LHAP MSCP (SSD 10388) - Addendum Letter

Liverpool Hospital
Elizabeth Street, Liverpool
NSW 2170
200811 SSDA MSCP Addendum (01)

APPENDIX A – ARCHITECTURAL DRAWING AMENDMENTS

DRAWING
GA GROUND 01 (ROAD LAYOUT)
PRINT DATE
11/08/2020

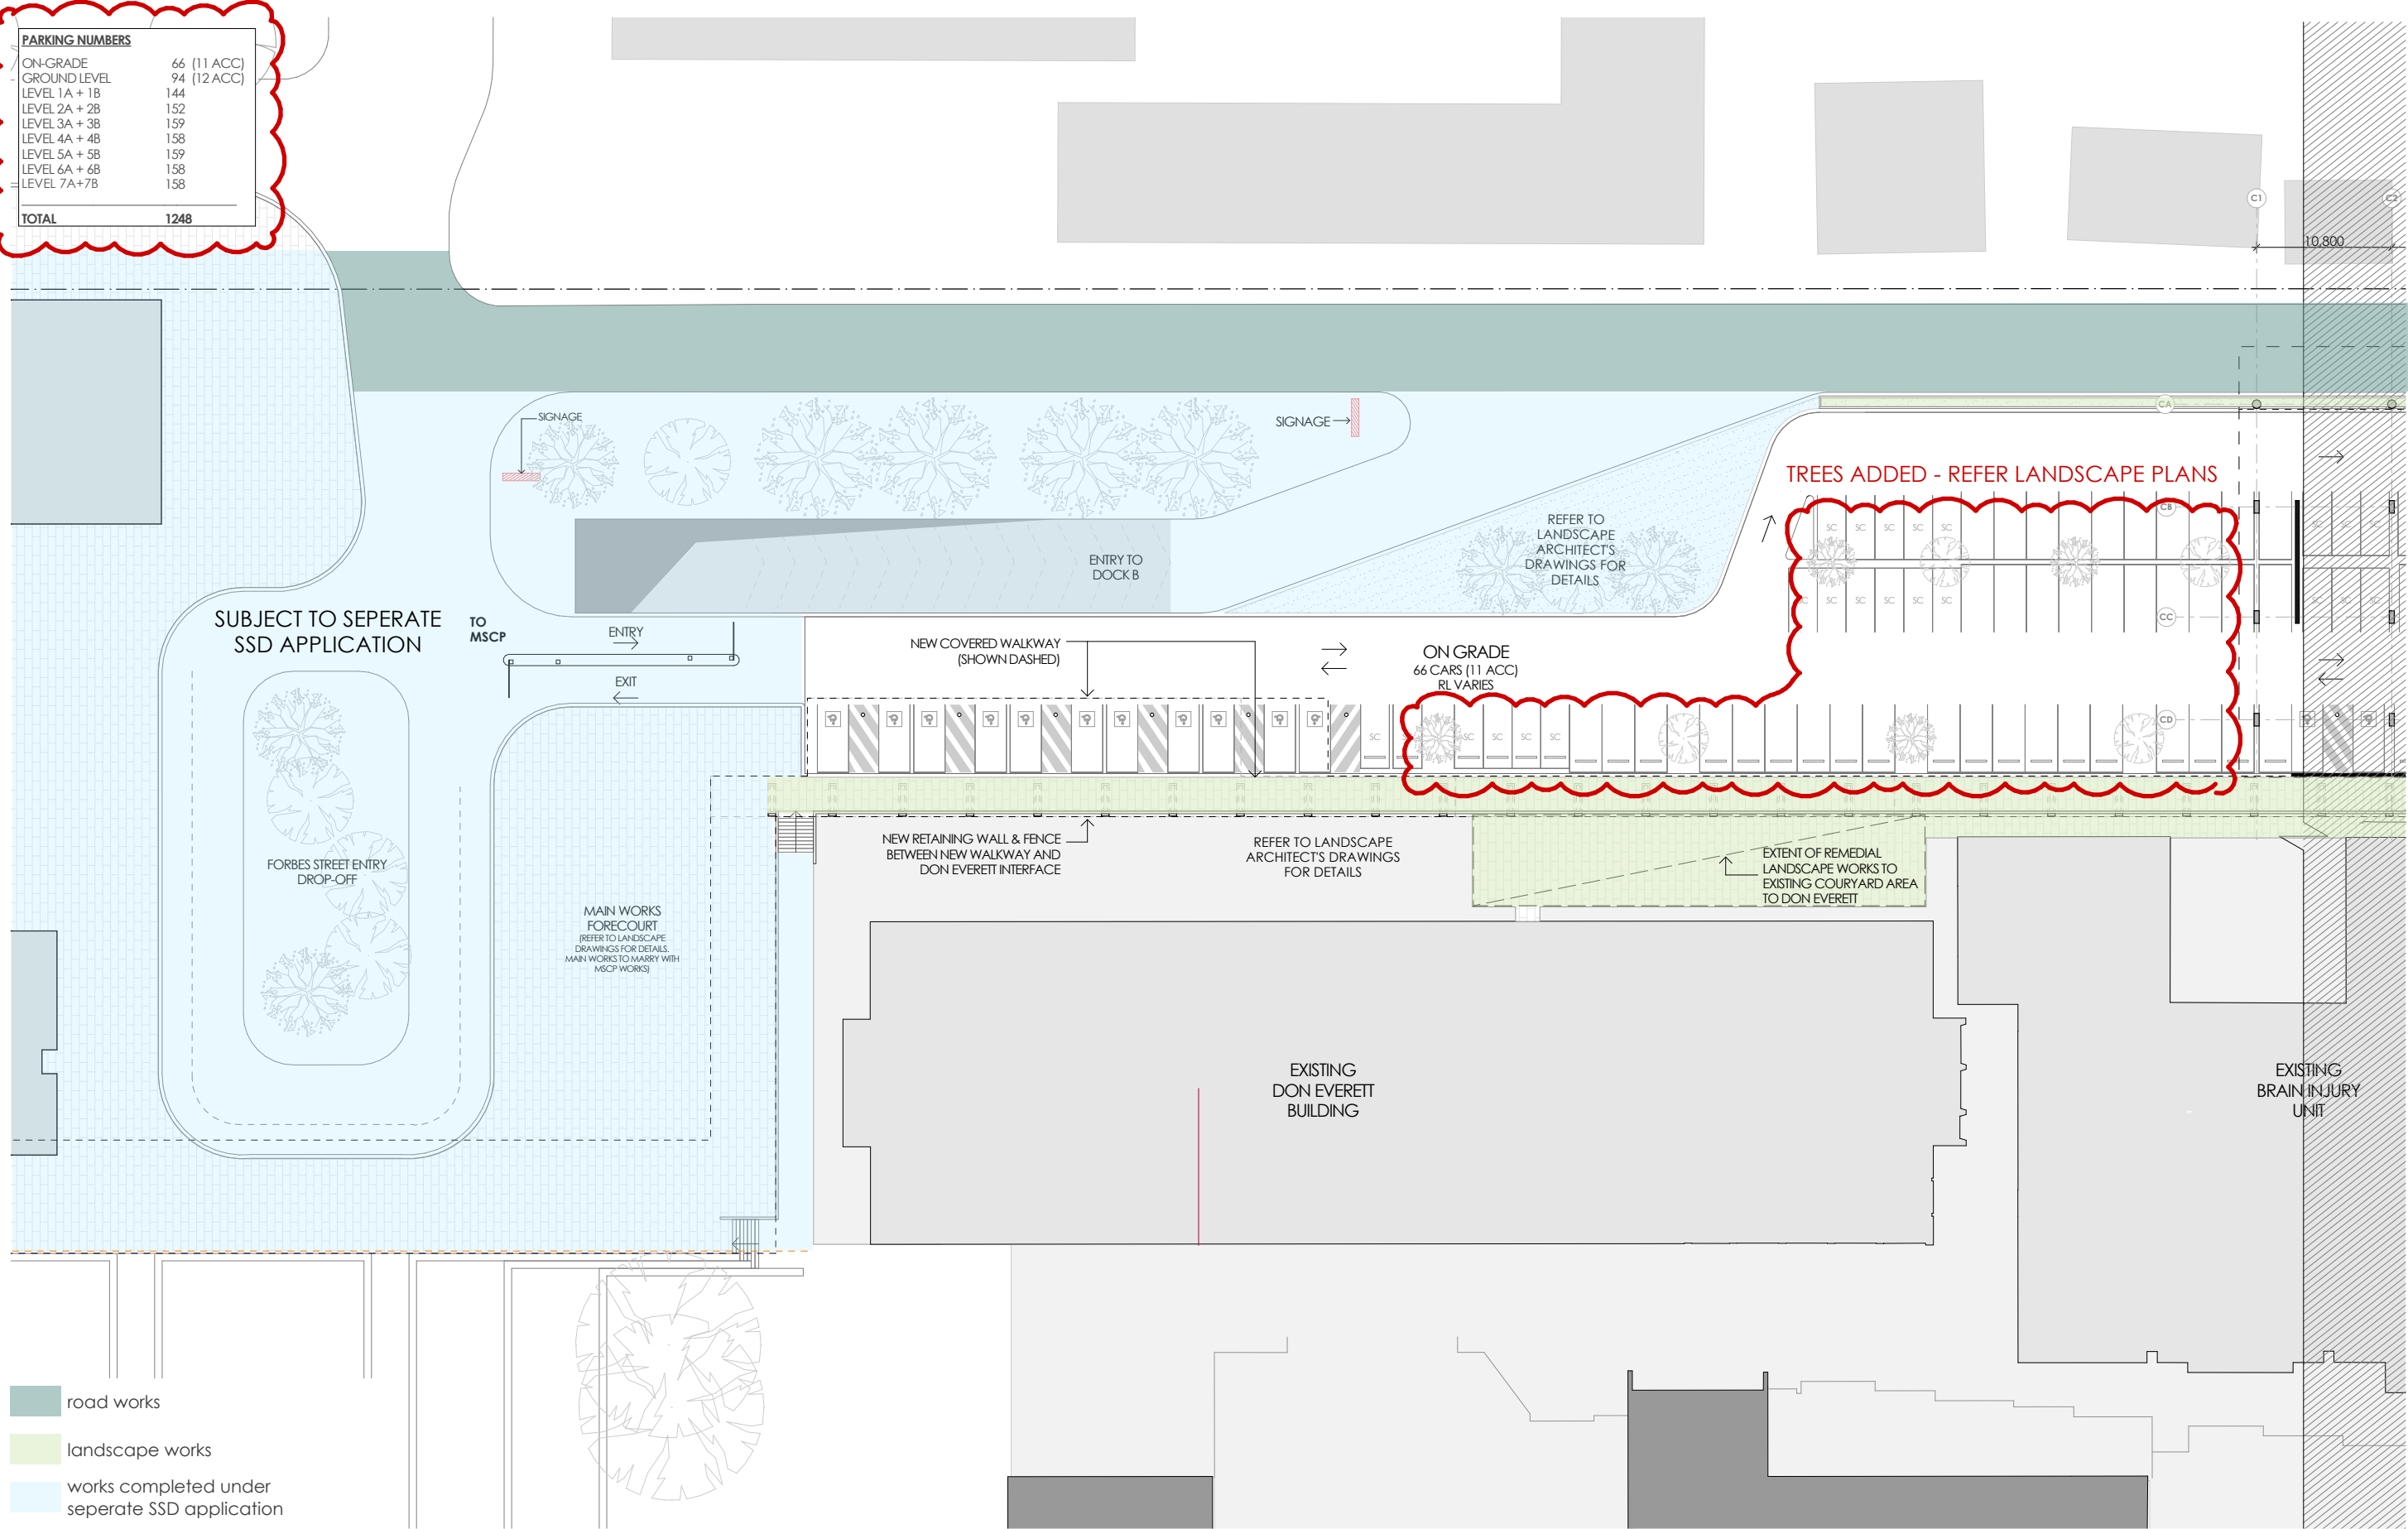
A-SSDA-MSCP-06 GA GROUND 01 (amended drawing)

- Summary of revised overall parking numbers
- Trees added to on-grade car park area (refer Landscape Architects drawings for details)

REVISED PARKING NUMBERS

PARKING NUMBERS	
ON-GRADE	66 (11 ACC)
GROUND LEVEL	94 (12 ACC)
LEVEL 1A + 1B	144
LEVEL 2A + 2B	152
LEVEL 3A + 3B	159
LEVEL 4A + 4B	158
LEVEL 5A + 5B	159
LEVEL 6A + 6B	158
LEVEL 7A+7B	158
TOTAL	1248

DRAWING
GA GROUND 02 (ROAD LAYOUT)
PRINT DATE
11/08/2020

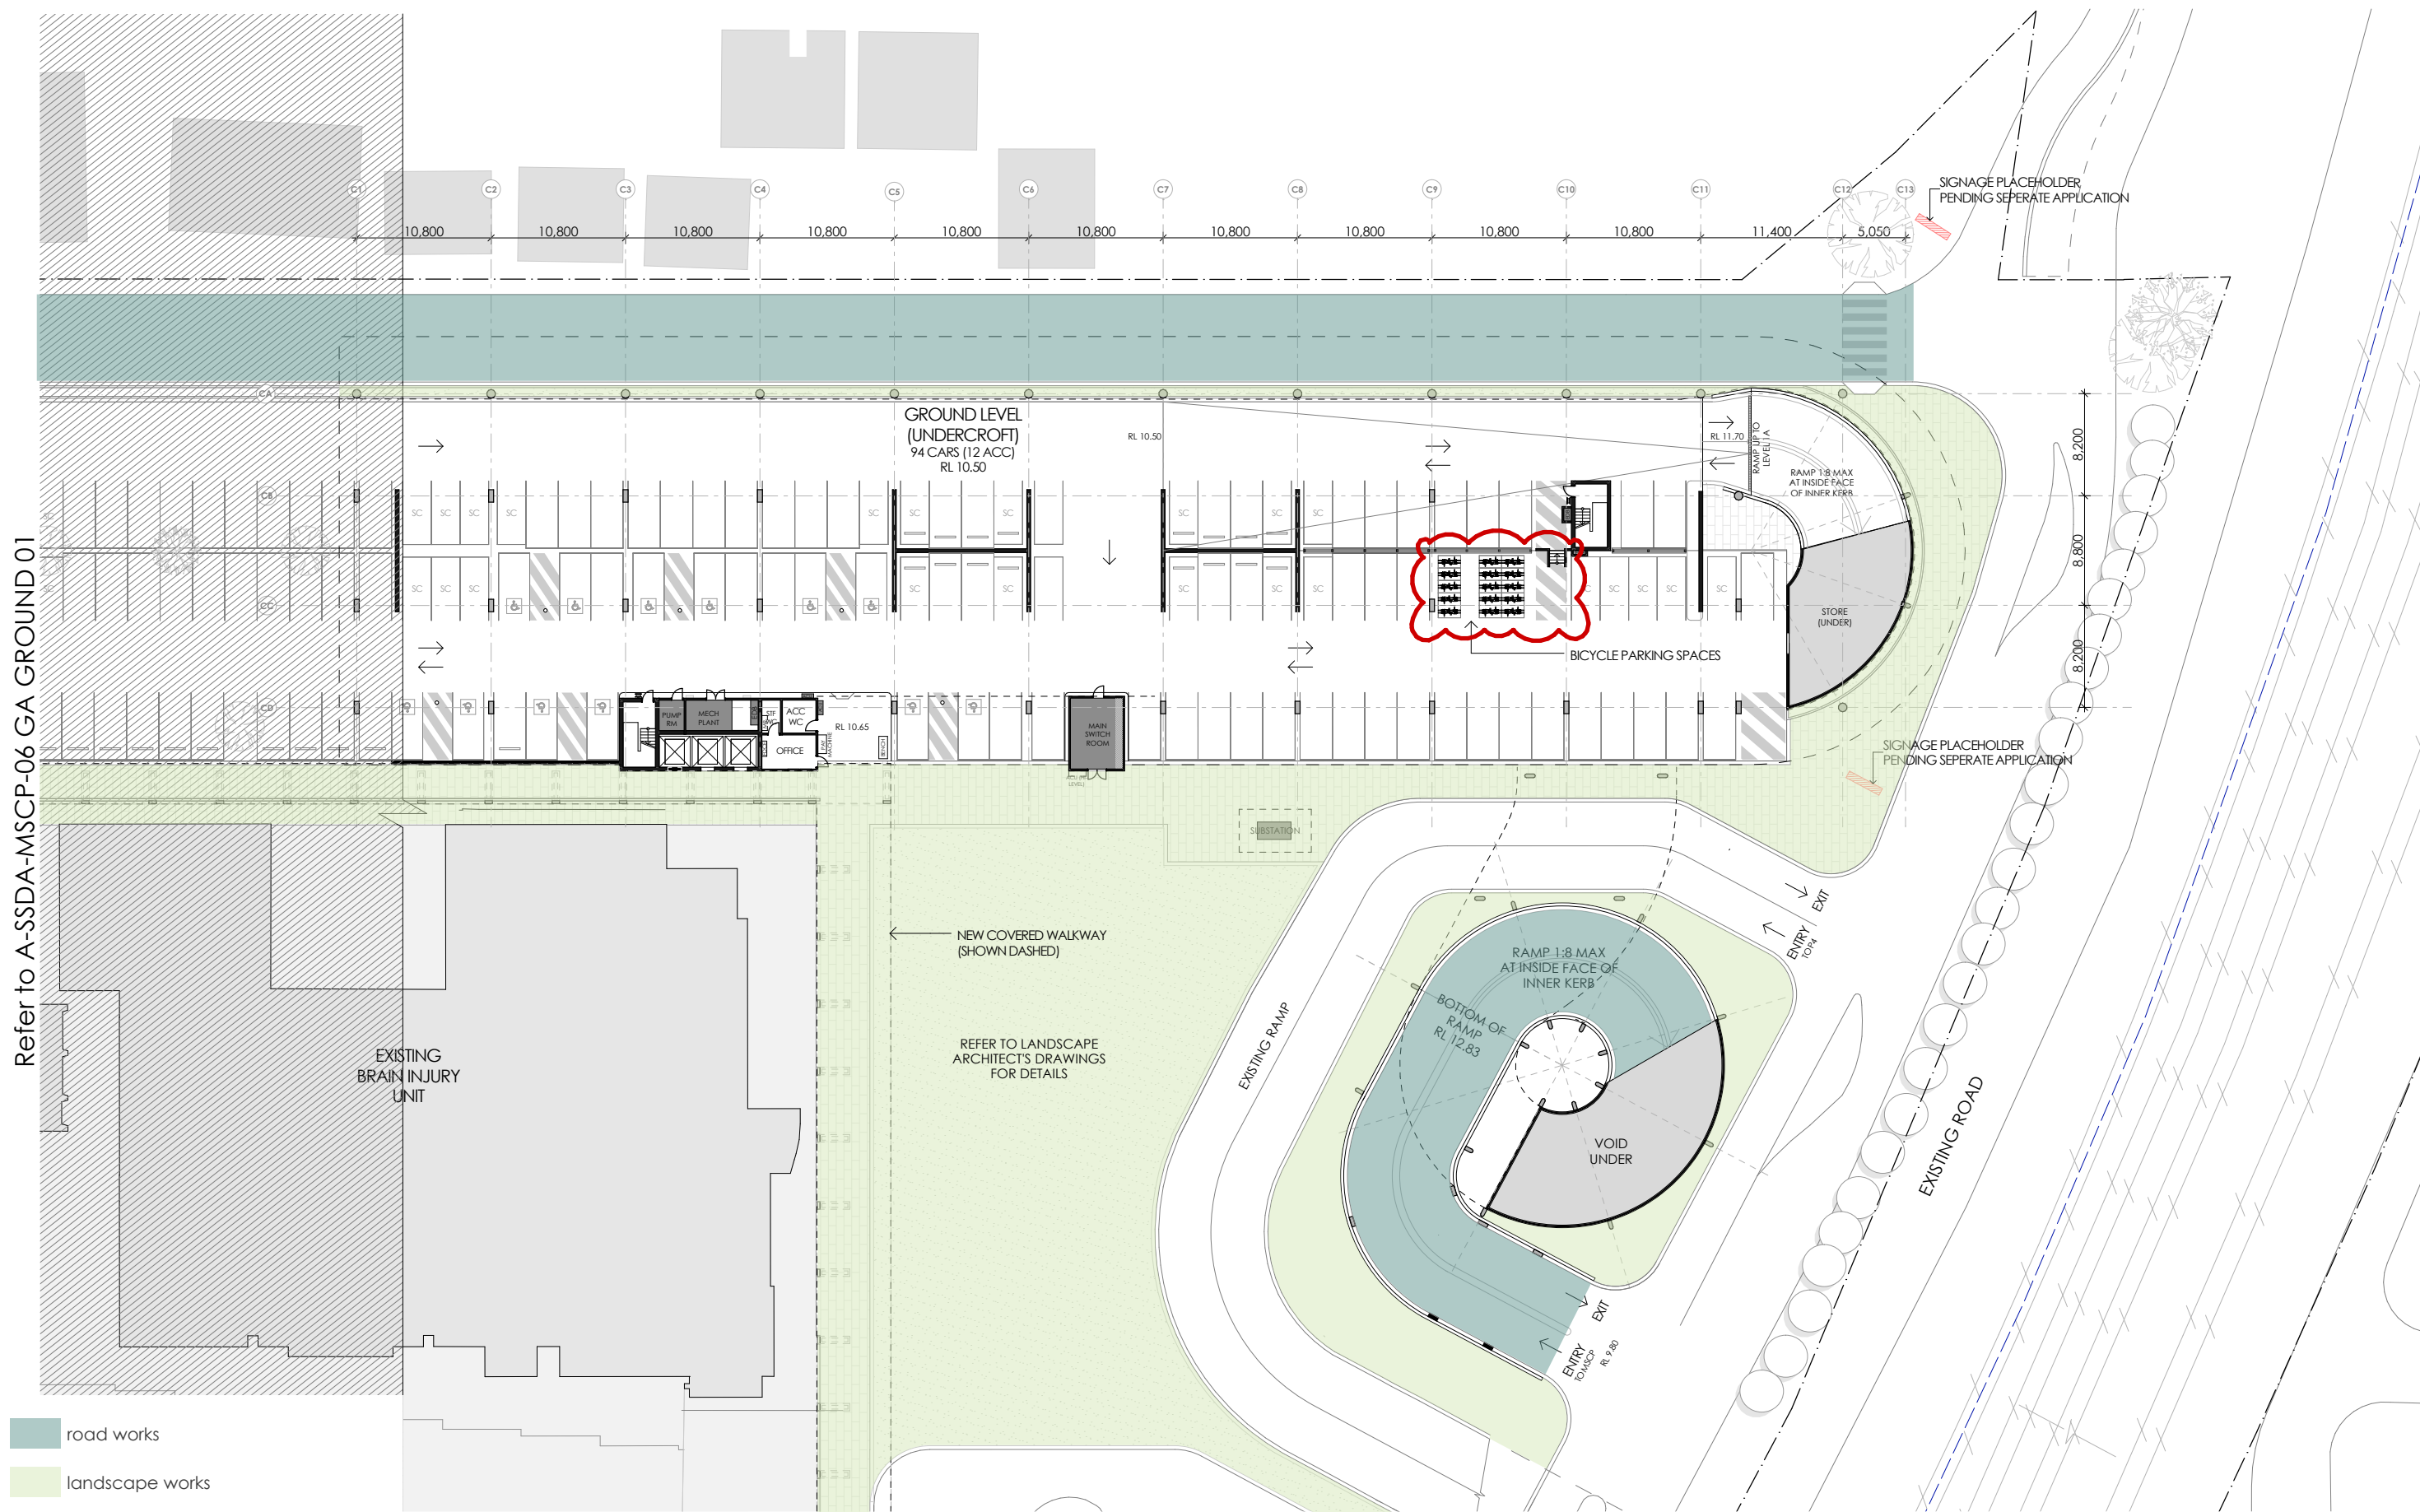
A-SSDA-MSCP-07 GA GROUND 02 (amended drawing)

- Undercover visitor bicycle parking location shown (25 spaces)

DRAWING
SECTIONS
PRINT DATE
11/08/2020

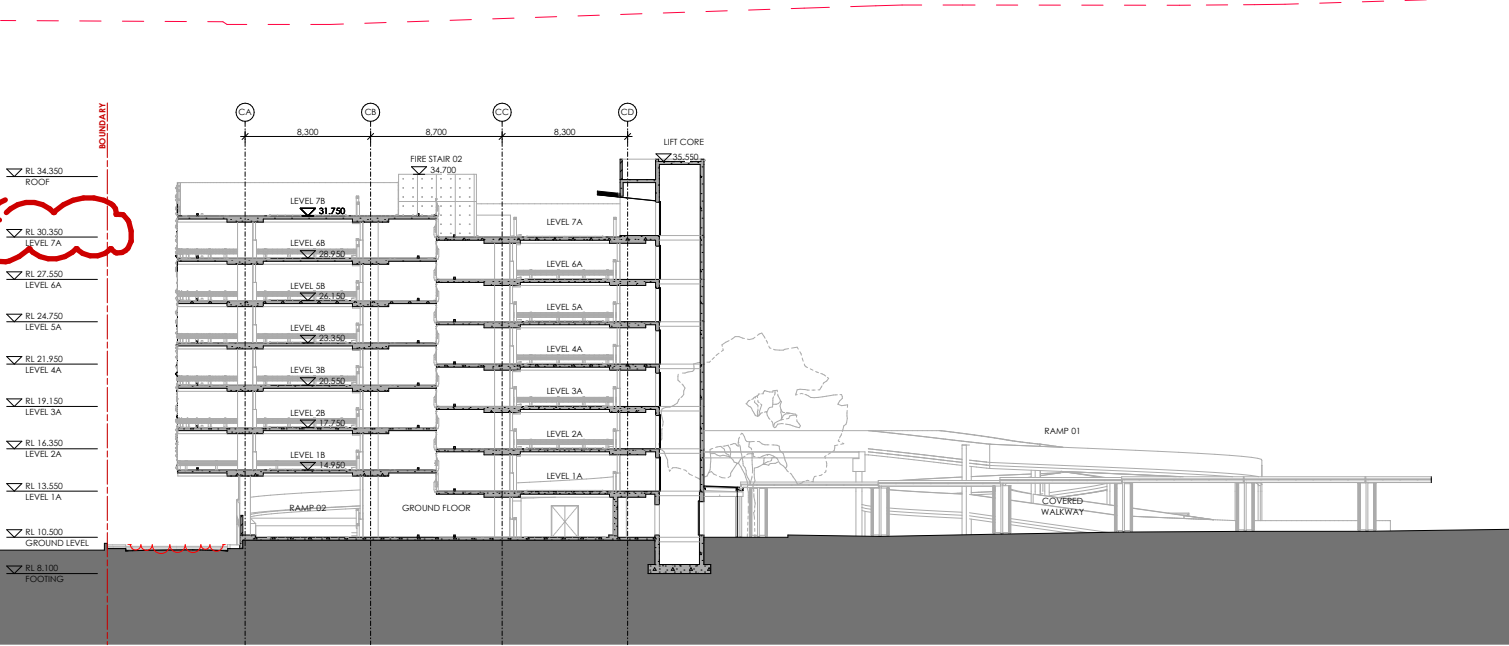
A-SSDA-MW-14 SECTIONS (amended drawing)

- Additional level (Level 7) added

DRAWING
ELEVATIONS
PRINT DATE
11/08/2020

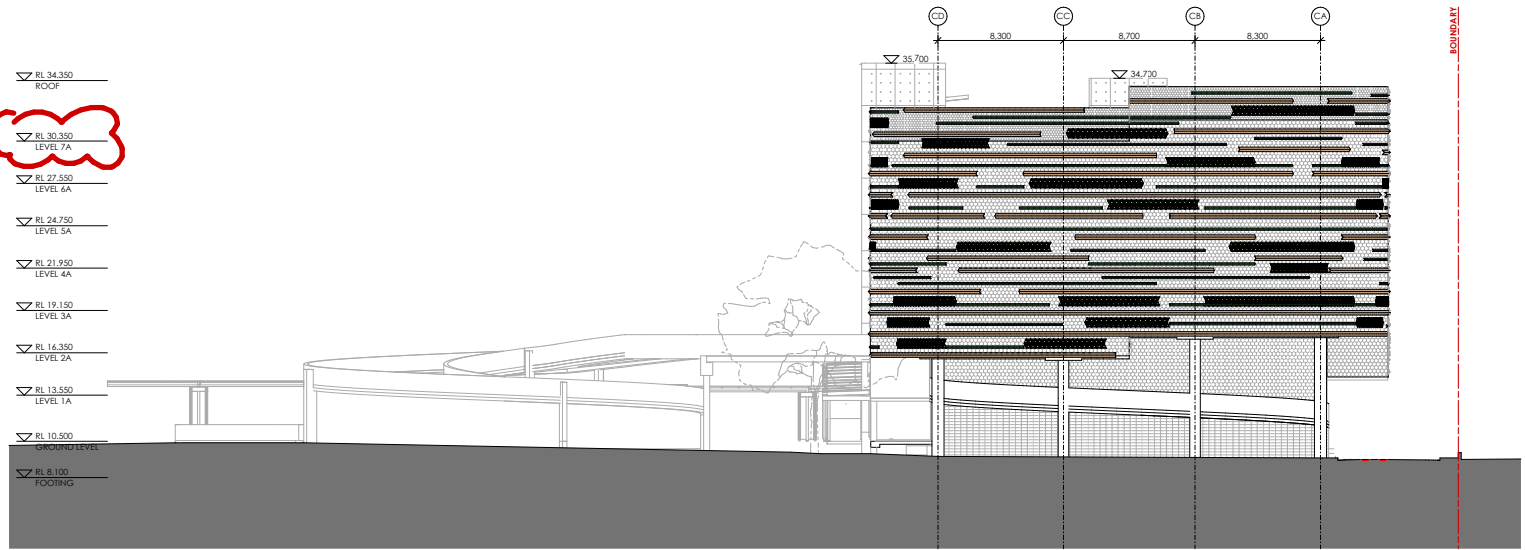
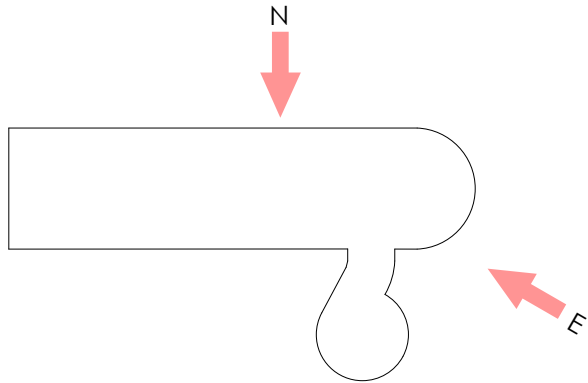
A-SSDA-MW-15 ELEVATIONS (amended drawing)

- Additional level (Level 7) added

DRAWING
ELEVATIONS
PRINT DATE
11/08/2020

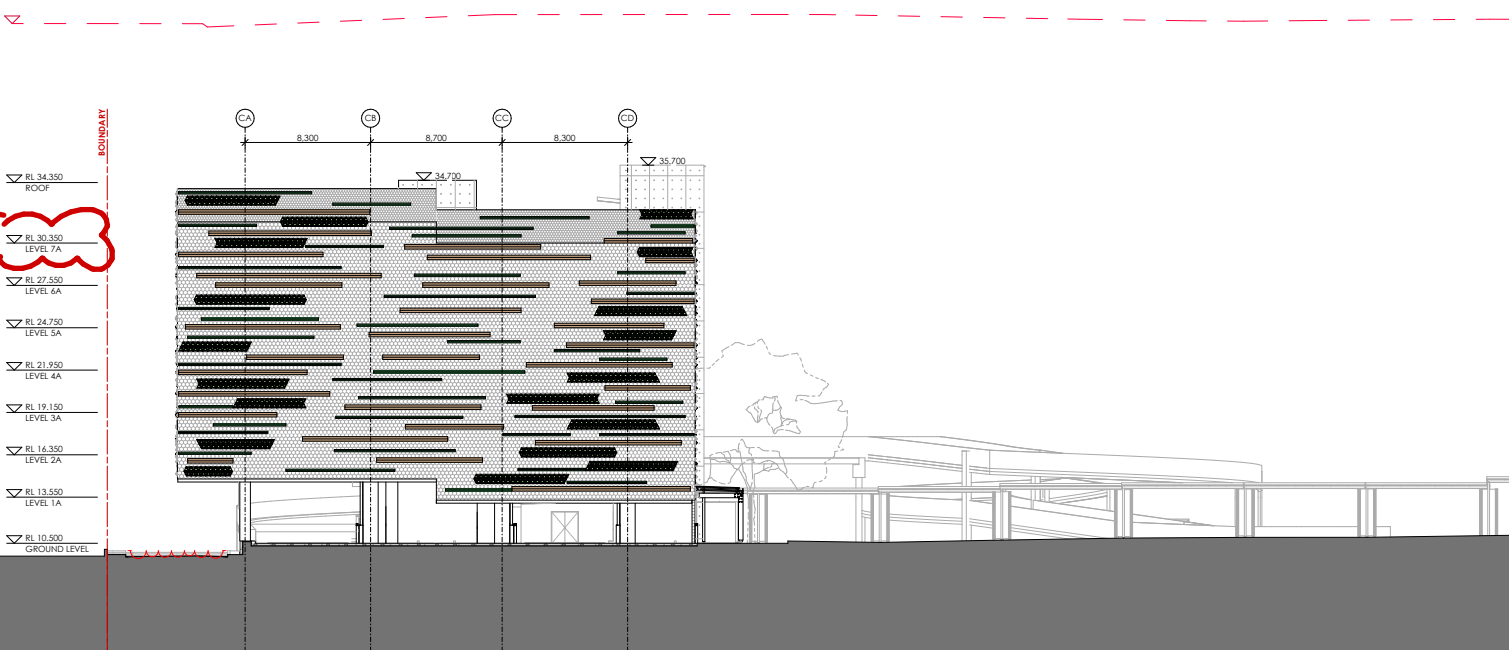
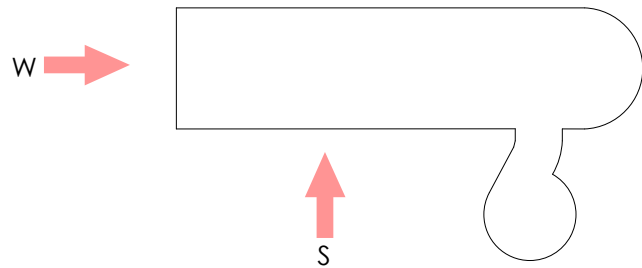
A-SSDA-MW-16 ELEVATIONS (amended drawing)

- Additional level (Level 7) added
